**CITY OF BEAUFORT  
DESIGN REVIEW BOARD  
Staff Report  
Meeting of May 12, 2016**

**Case Number:** 16-02 DRB.3  
**Project:** Home2 by Hilton  
**Property Address:** Parris Island Gateway & County Shed Road  
**Parcel #:** R120 026 000 0160 0000 (a portion of this parcel)  
**Zoning:** Highway Commercial  
**Design District:** US 21 Design District  
**Type of Review:** **Final Review – New Construction**

**7M SMOKE HUT ELEVATIONS**  
SCALE: 1/4" = 1'-0"

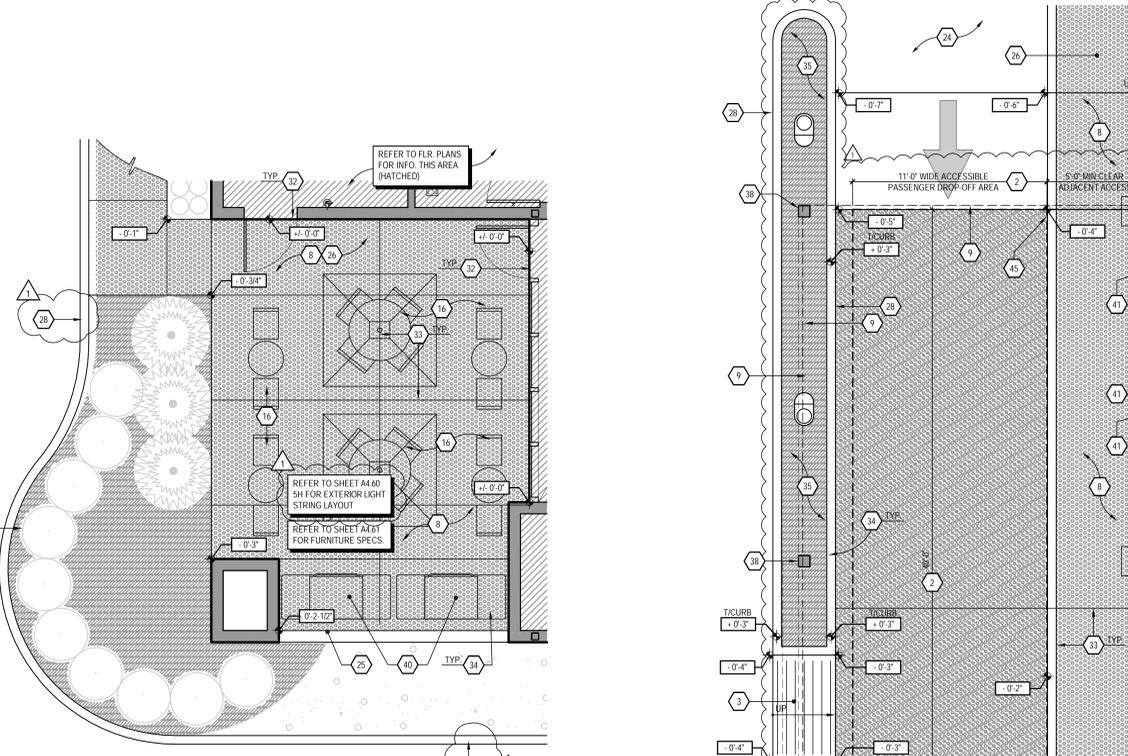
- Smoke Hut: What is the "Masonry or Tile – Field Ashlar Pattern"
- A tree mitigation calculation will be required based on Green and Orange trees in arborist report proposed to be removed.
